CTV Building - GF calculations relating to possible collapse scenarios

Further to Clark Hyland's DBH Report on the CTV Bldg collapse, I think the points below could have received a little more attention in that report - or offer alternative views to some of the report findings.

PLAN SECTION 2-2 - INTERIOR BEAM-COLUMN JOINT
 (ALLOWING 10mm CONSTRUCTION TOLERANCE)

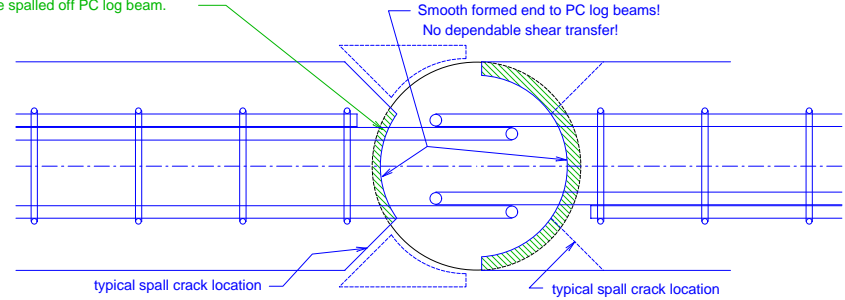
And the bearing stress calculated above assumes columns and beams were built **and located** in PERFECT accordance with the plans. It is quite conceivable that the 25mm bearing width detailed on the drawings could have ended up being much lower. Allowing for just 10mm construction tolerance, support area at one beam end could easily have been as low as $A_{\min} := 3510\text{mm}^2$. (see CAD File: *CTV Bldg - Interior Beam-Column Joint - GF 20120215.dcd*)

This would have resulted in an unfactored bearing stress in the order of $\frac{0.5P_g}{A_{\min}} = 41 \cdot \text{MPa}$

PLAN SECTION 3-3 - INTERIOR BEAM-COLUMN JOINT
 (ALLOWING 10mm CONSTRUCTION TOLERANCE + CORNER SPALLING)

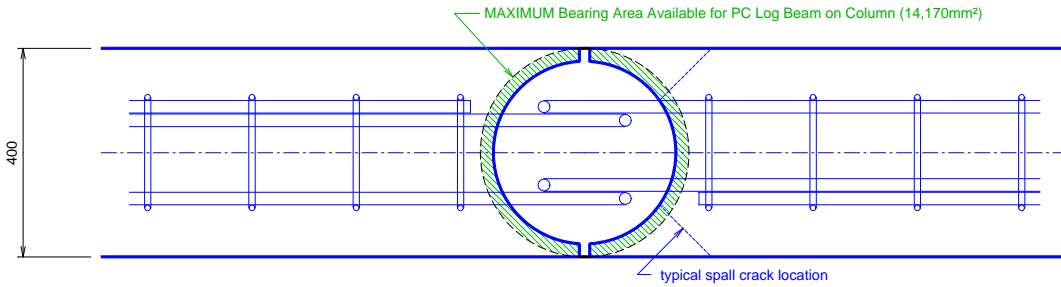
If the outer corners of the log beams have spalled off (all the POST-collapse specimens exhibited this situation - and there was no confining steel detailed to prevent this occurrence - see Point 3 below), the available bearing area reduces significantly. Many of the beam ends were left with less than 200mm width at the bottom after the corners had spalled off.

PLAN SECTION 1-1 - INTERIOR BEAM-COLUMN JOINT
 (AS DESIGNED)

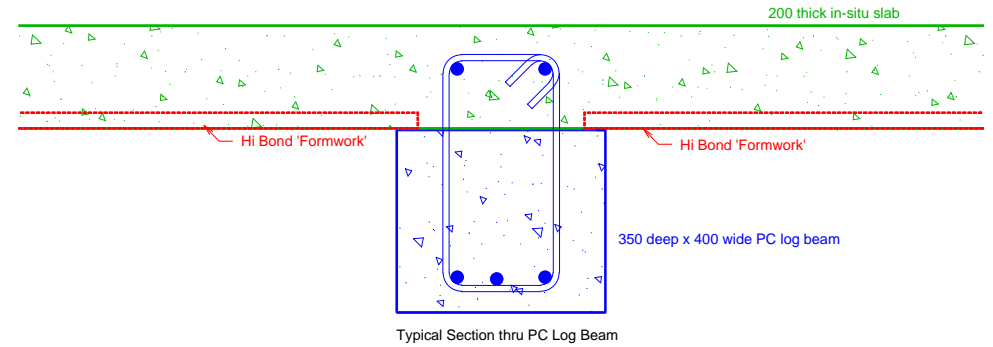
Post collapse photos show that the ENDS of the precast units were made with a very smooth formed finish. Consider also that with very little inter-storey drift, the vertical joint between a beam end and the column core concrete would, on one side, be opening up below slab level (since the bottom longitudinal beam bars were inadequately anchored beyond that joint) - reducing any available friction on the curved vertical beam end face to zero AND reducing what was initially designed as a very narrow seating width (for the precast beam on the column cover concrete below). If all this single floor dead load is transferred through the 25mm wide (as designed) seating for the precast log beams on the 400Ø column, we would have a bearing stress of at least:

$$f_p := \frac{P_g}{\pi \cdot \left[(0.2\text{m})^2 - (0.175\text{m})^2 \right]} = 9.8 \cdot \text{MPa}$$

LONGITUDINAL SECTION - TYPICAL INTERIOR BEAM-COLUMN JOINT

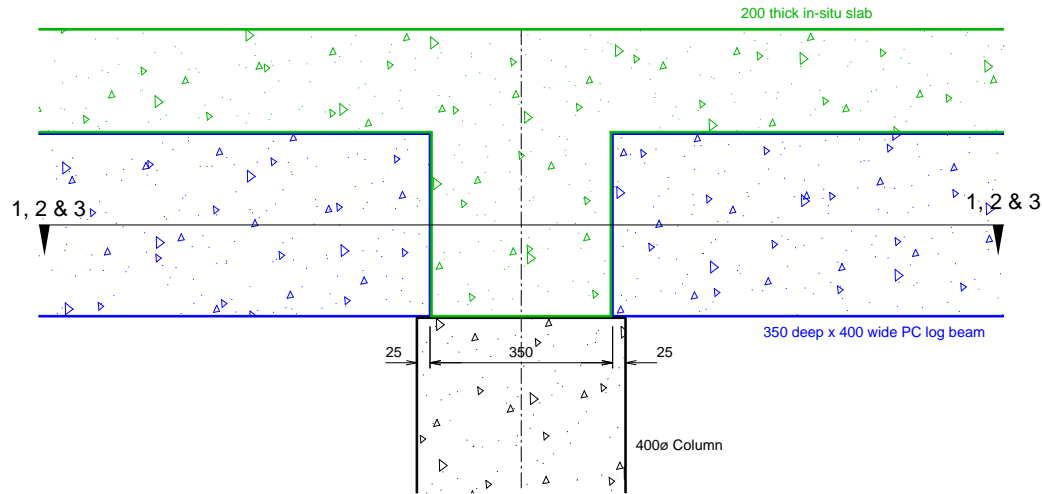
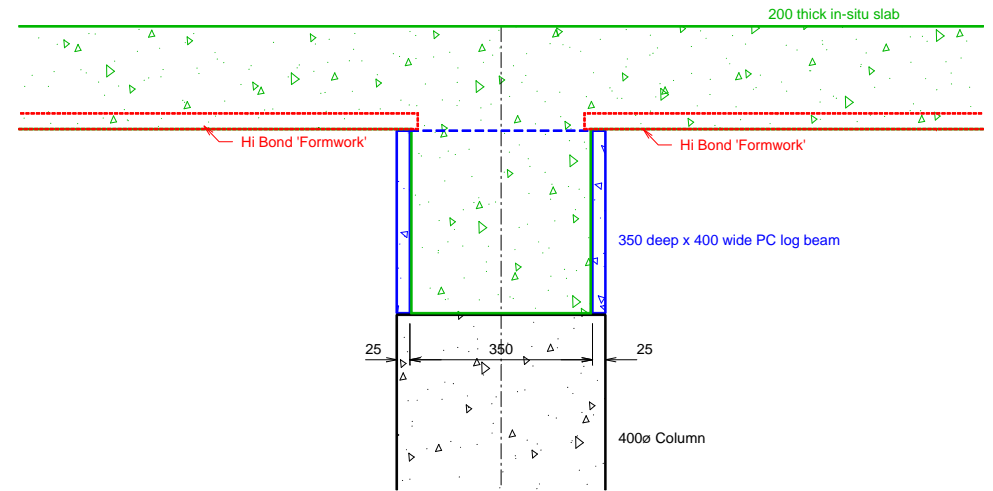
End stirrups in precast log and shell beams were often not located close enough to the end of precast - i.e. too far away from column centreline. Some measured up to 300mm! (See photo DSCF 6888). This exacerbates the condition discussed in Point 1 above.
